Item Name: Replacement Skidtube, Low Gear with Standard Wearplates Fits LH or RH

Draw Nbr	Revision Nbr
D2650	Rev F(DEO)

DRAWING NO. D2650	TITLE 206/407 SKIDTUBE ASSEMBLIES	REV. F	DART AEROSPACE LTD ENGINEERING ORDER		D.E.O. NO. D2650-F-1	SHEET NO. SHEET 1 OF 1	SCALE NTS
DRAWN <i>IP</i>	CHECKED <i>A.P.</i>	MFG. APPR. <i>AA</i>	APPROVED <i>TH</i>		DE APPR. <i>TH</i>		
DATE 12.10.12	DATE 12.10.22	DATE 12.10.22	DATE 12.10.22		DATE 12.10.22

CHANGE C'BORED WELDED CROSSBOLT SPACERS TO SWAGED SPACERS

WAS:

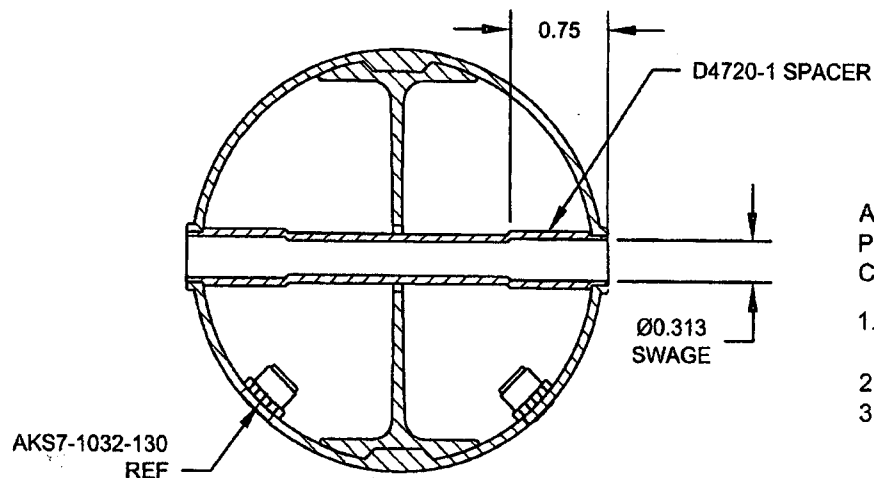
17	18	19	23	D2649	CROSS BOLT SPACER
----	----	----	----	-------	-------------------

DETAIL G

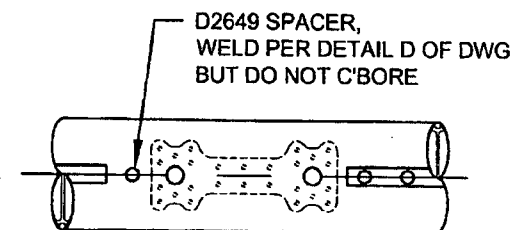
ADD DETAIL G BELOW, WHICH IS THE SAME SECTION VIEW AS DETAIL D OF DWG.
C'BORED HOLES ARE **NOW SWAGED** PER DETAIL G BELOW. FOR THE Ø0.375 HOLE THAT IS NOT C'BORED, WELD PER DETAIL D OF DWG (SEE AMENDED DETAIL B FOR REFERENCE).

FOR Ø0.375 HOLES ONLY
FOR HOLES THAT ARE CURRENTLY C'BORED ONLY
NOT TO SCALE
